Project	IEEE 802.16 Broadband Wireless Access Working Group < http://ieee802.org/16 >	
---------	---	--

Title	MAC Header Format Modifications	
-------	--	--

Re:	This document is submitted in response to 802.16 Letter Ballot #3	
-----	---	--

FIGURE 1. Bandwidth Request Header Format

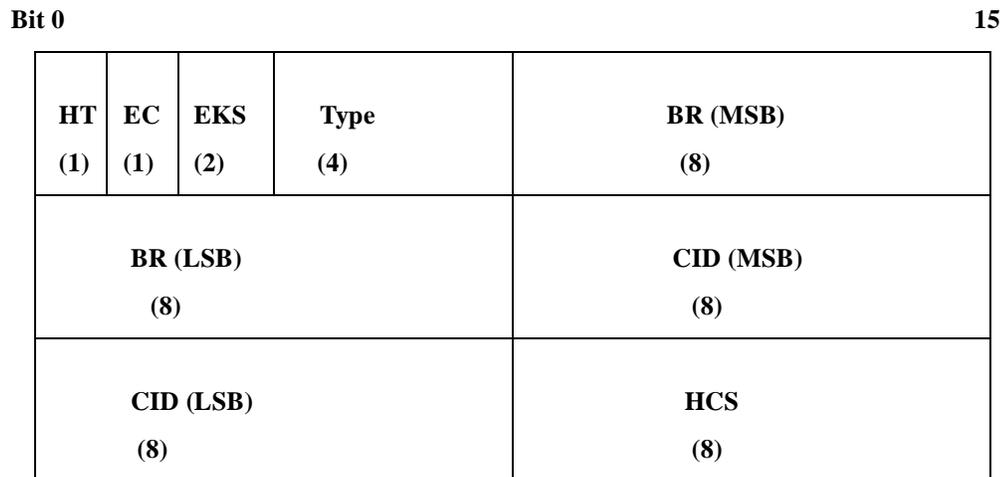
Replace Figure 20 in IEEE 802.16/D2-2001 by Figure 1 in this contribution.

It is possible to slightly modify the Bandwidth Request packet, in order to define the uplink ACK packet, as shown in Figure 1. There is a 4 bit Type field that can be used to identify other kind of control packets. Thus Bandwidth Requests and Uplink Acks can be assigned different Types.
